Status: Y N U **Area Walk-By Checklist (AWC)**Location: Bldg. REACTOR Floor El. 87 Room, Area¹ NW Diagonal Elevated Platform**Instructions for Completing Checklist**

**This attachment contains Appendix H from the report entitled,
“Edwin I. Hatch, Unit 1 and Unit 2, Individual Plant Examination of
External Events – Seismic”**

UNIT 2 – SEISMIC WALKDOWN ENGINEER CERTIFICATIONS

Photographs

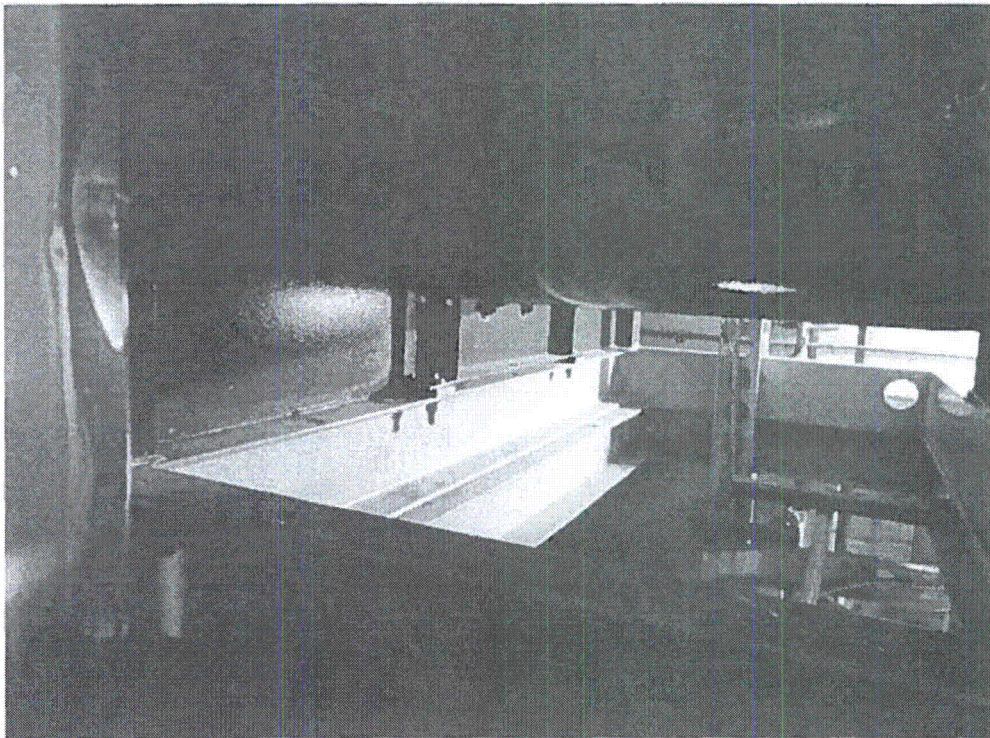
1. Does anchorage of equipment in the area appear to be free of potentially adverse seismic conditions (if visible without necessarily opening cabinets)? Y N U N/A
Equipment 2T41-B004B has a missing bolt. See picture for details. CR523718 has been initiated for this purpose.

1: Unsupported Conduit 2E23664 (Switchgear Room 2G)

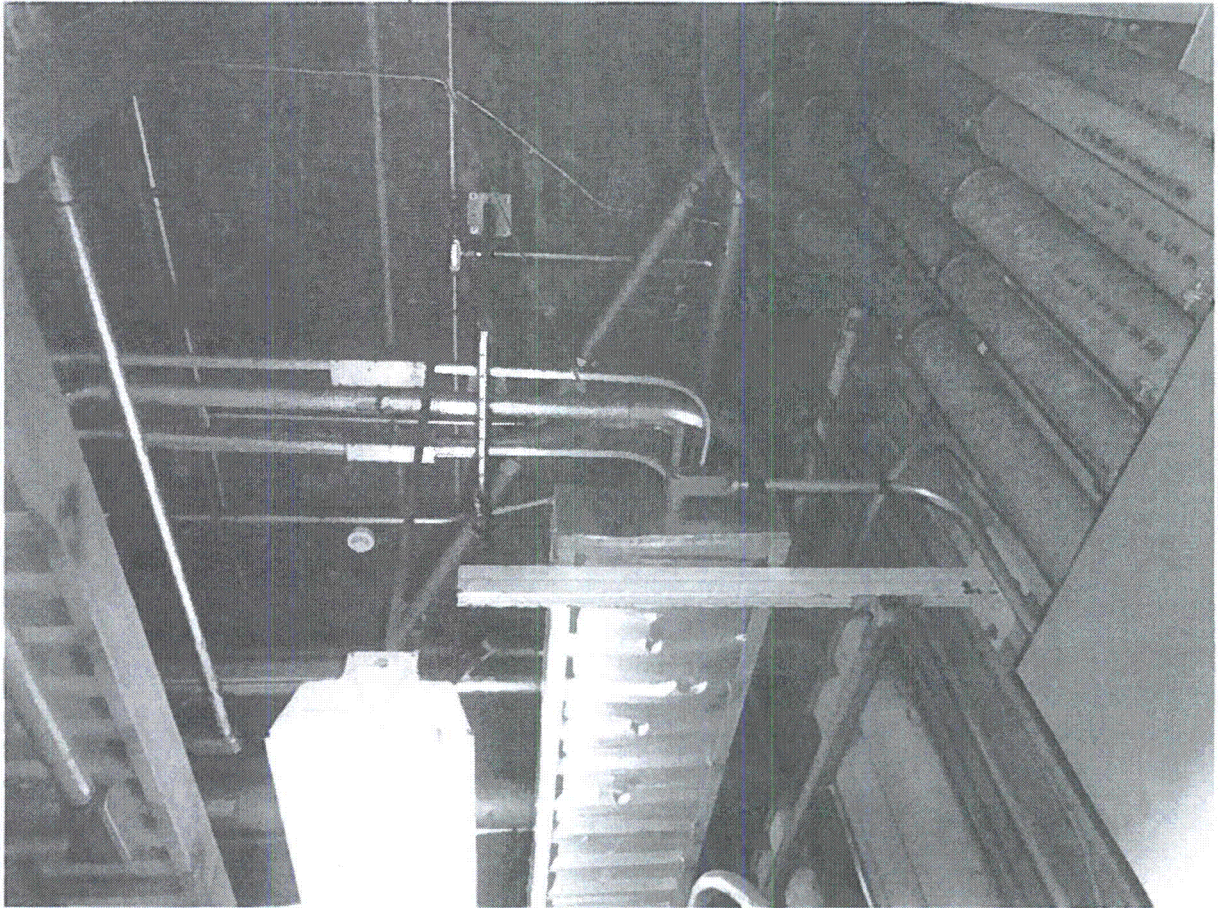
3. Based on a visual inspection from the floor, do the cable/conduit raceways and HVAC ducting appear to be free of potentially adverse seismic conditions (e.g., condition of supports is adequate and fill conditions of cable trays appear to be inside acceptable limits)? Y N U N/A
Two cases were observed where conduit spans appeared to be longer than standard practice (see pictures 1 and 2). However, those spans were judged to meet the intent of section 8.0 of the SQUG GIP which allows spans of 20 feet for conduits of this size. Thus, the conduits are seismically adequate.

Conduits 3" and larger are seismically acceptable when the vertical spacing is less than 20 feet (section 8.2.2, SQUG GIP).
4. Does it appear that the area is free of potentially adverse seismic spatial interactions with other equipment in the area (e.g., ceiling tiles and lighting)? Y N U N/A

1: Nuts Not Fully Tightened for Conduit Column Support (2R103)

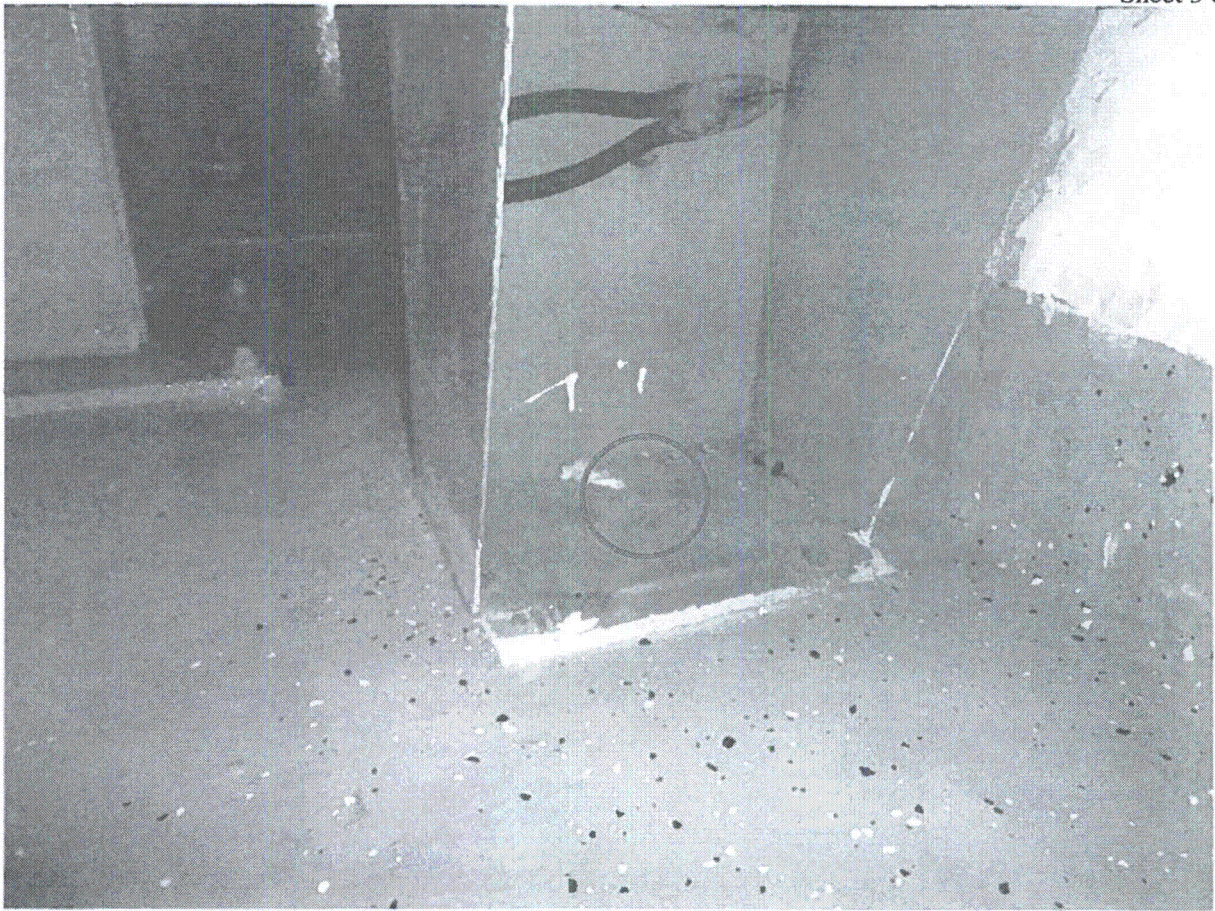
- A steel base plate for a column conduit support near airlock 2R106 has two anchors with nuts not fully tightened (see photograph 1). There is approximately a 1/8" gap between the bottom of the nuts and the top of the plate. Deflections will increase slightly due to this, though the support is judged to be seismically adequate as the anchors are embedded in the concrete and will resist the tension forces experienced during an event as intended. CR 519997 has been written to resolve this issue.*

2: Missing Anchor for Cantilever Support Off West Wall (2R103)

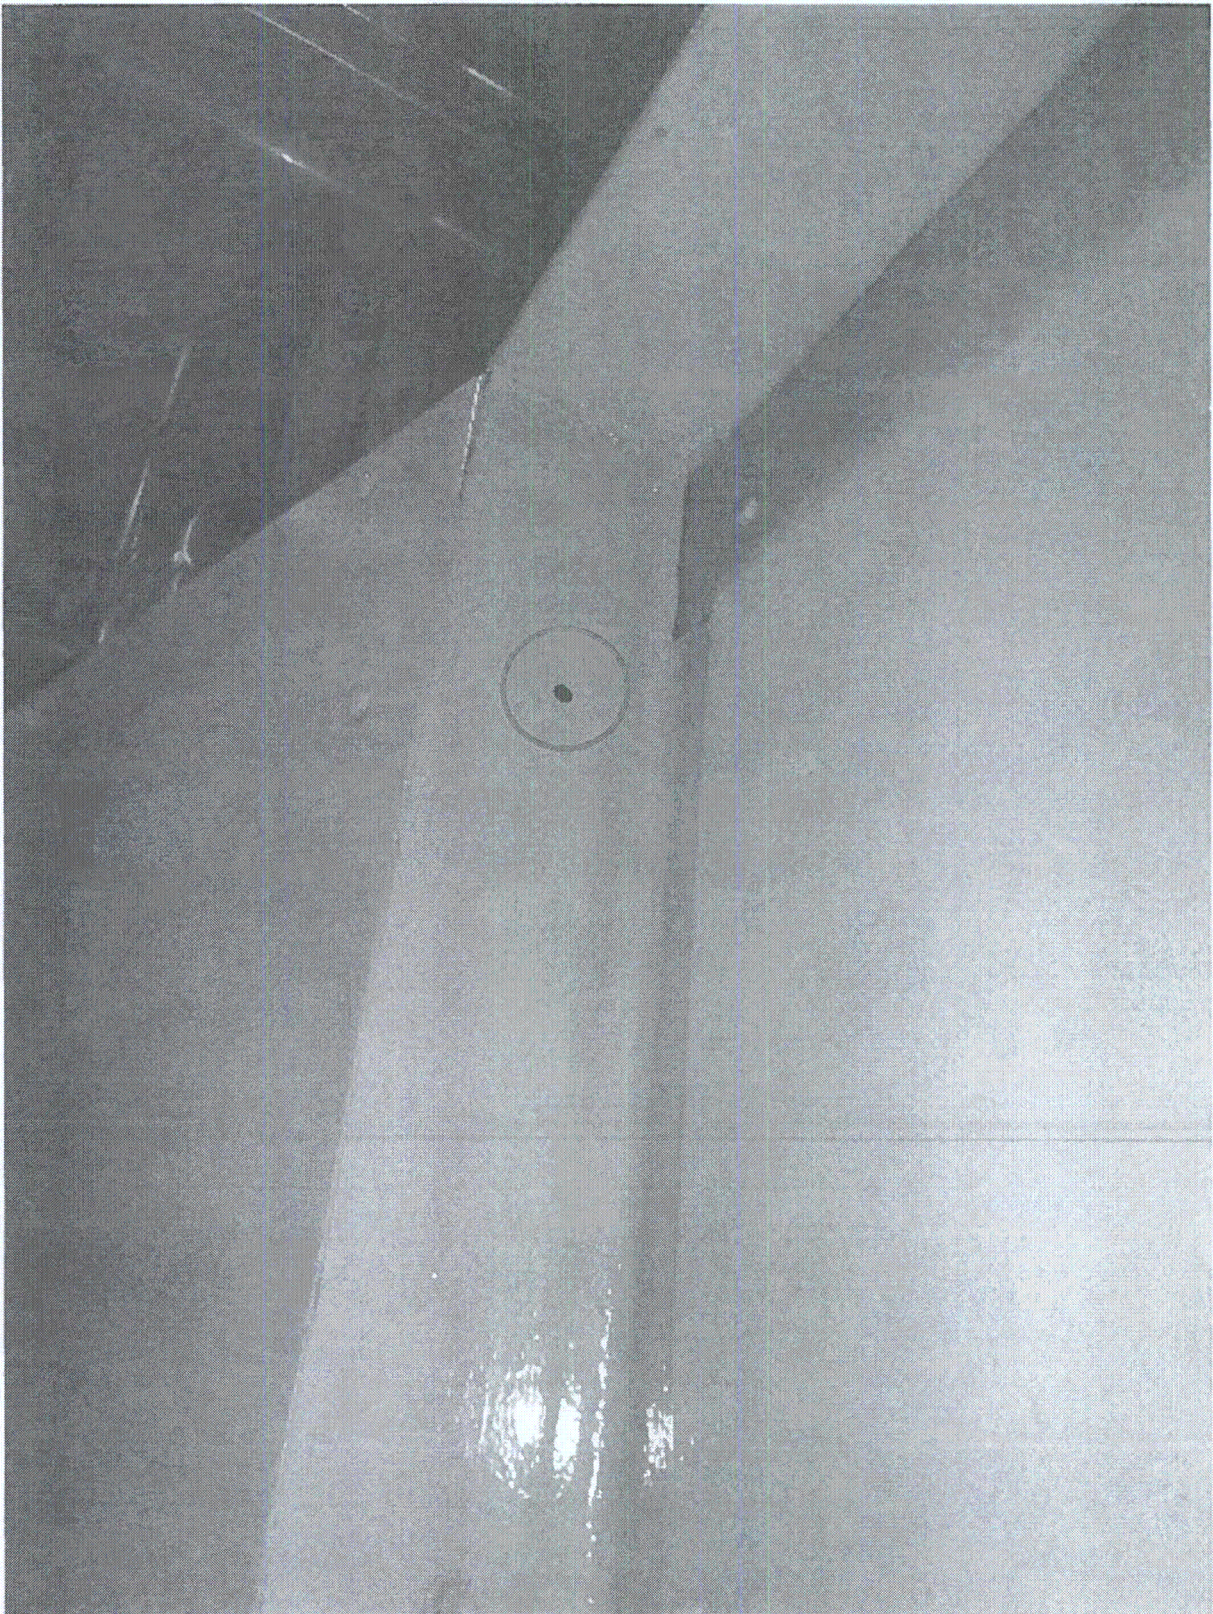
- There is a cantilevered frame supporting a circular duct on the west wall missing an anchor bolt (see photograph 2). The adjacent support has all three anchors though the top and bottom anchors are missing washers. The two anchors present allow for the tension/compression action to occur in the event of movement during a seismic event. The duct weight isn't significant over the span observed to be supported and the support is judged to be seismically adequate. CR 519729 has been written to install the missing anchor and washers.*

Figure 1 – Tubing Support Missing Bolt (NE Diagonal Unit 2)

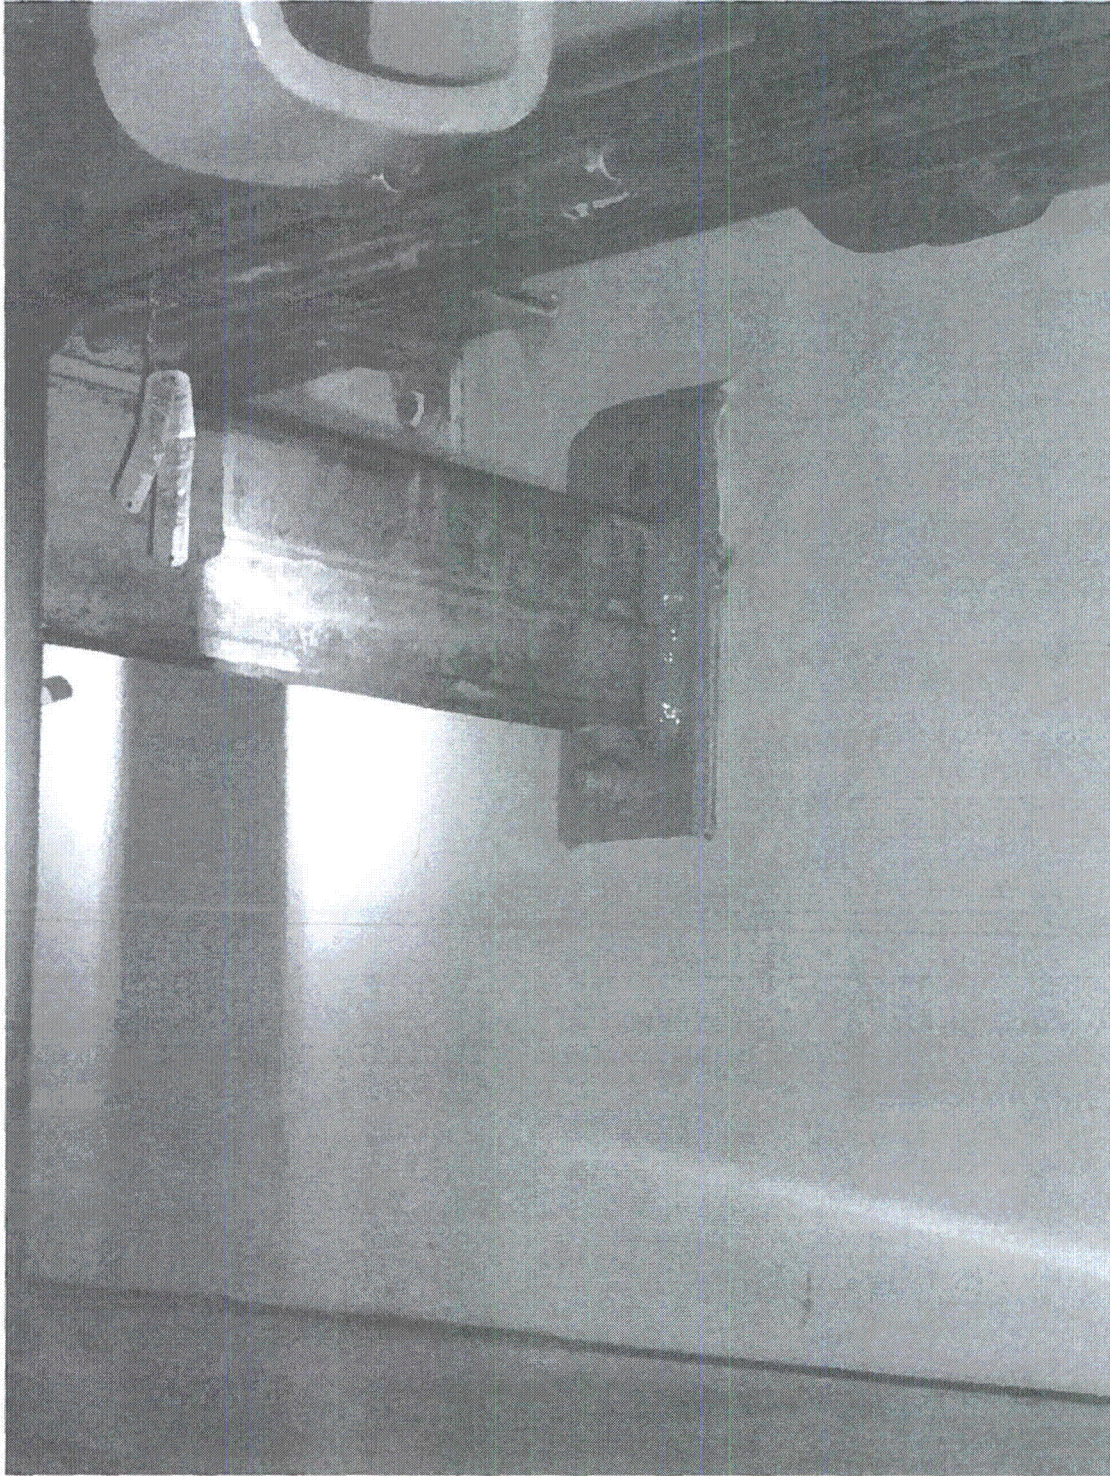
There is one anchor bolt missing from a two-bolt support for the tubing near valve 2E11-F252A. Figure 1 shows a weld along the edge of the base-plate closest to the location of the missing anchor bolt. This weld will carry the load that would be carried by the missing anchor. Therefore, the support is seismically acceptable.

Figure 1 – Loose Pipe Insulation (SE Diagonal Unit 2)

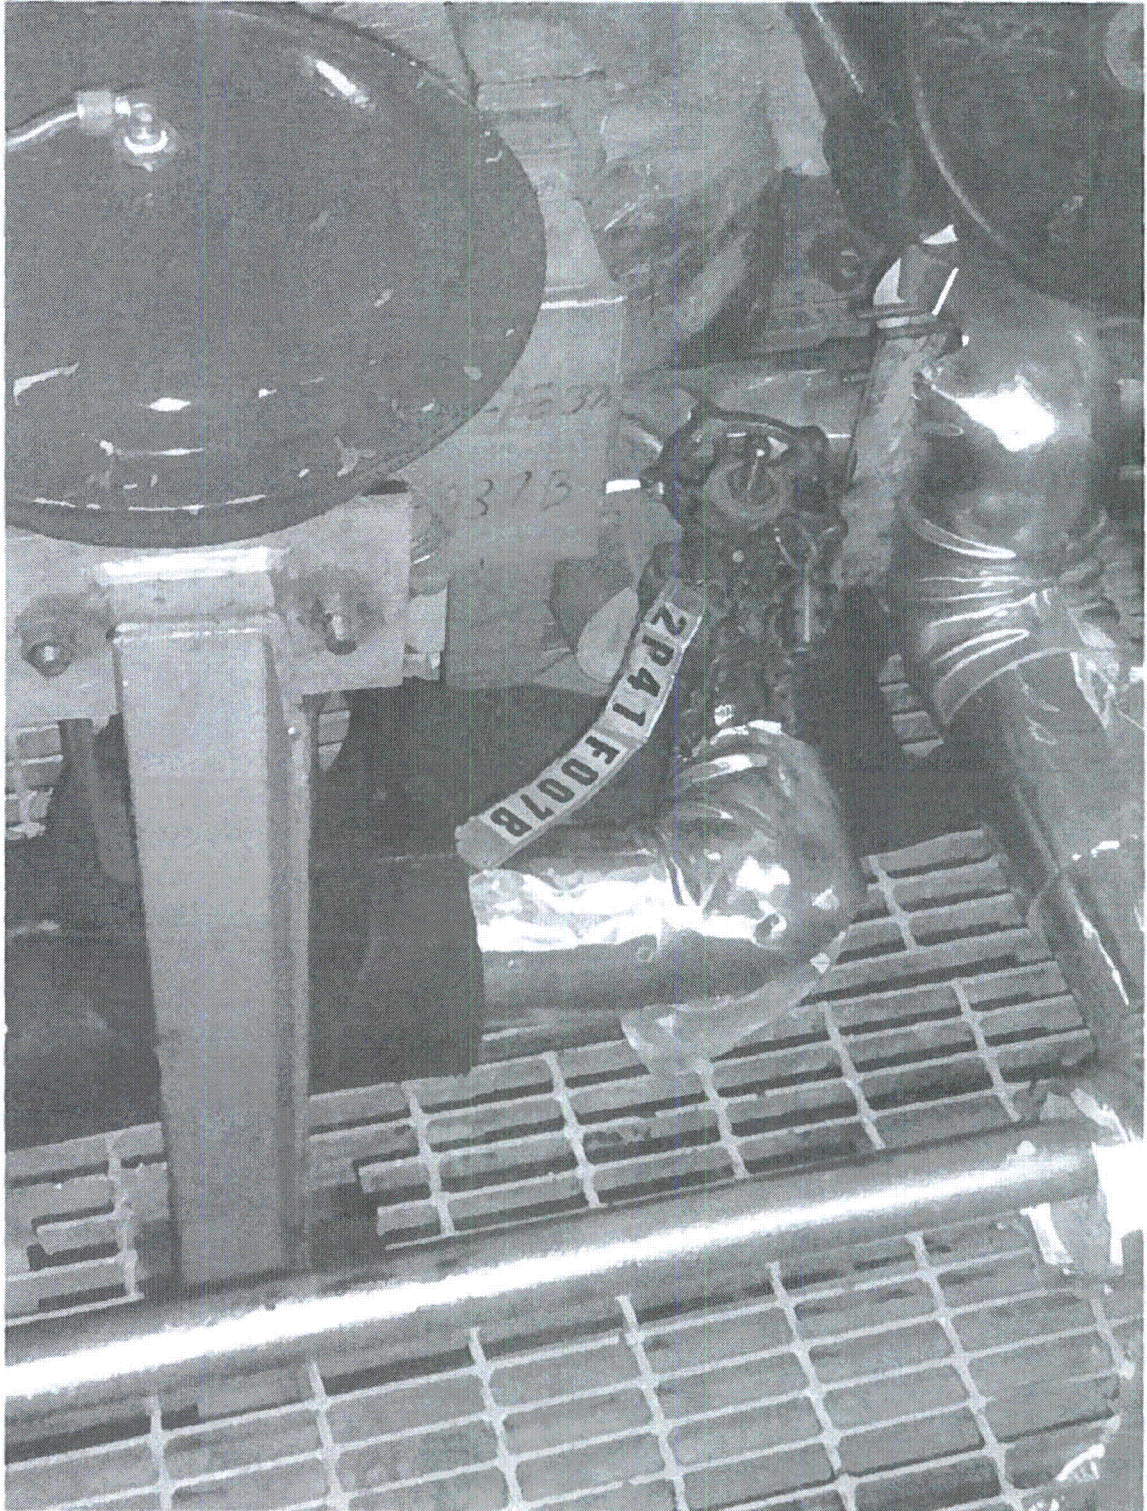
There are two loose items behind the 2E11-B001B Heat Exchanger: a small plastic nozzle and a piece of foam insulation that has become dislodged from around a valve. Both items are small and light, and are not near any sensitive equipment. Therefore, the items are judged to not be a potentially adverse seismic condition.
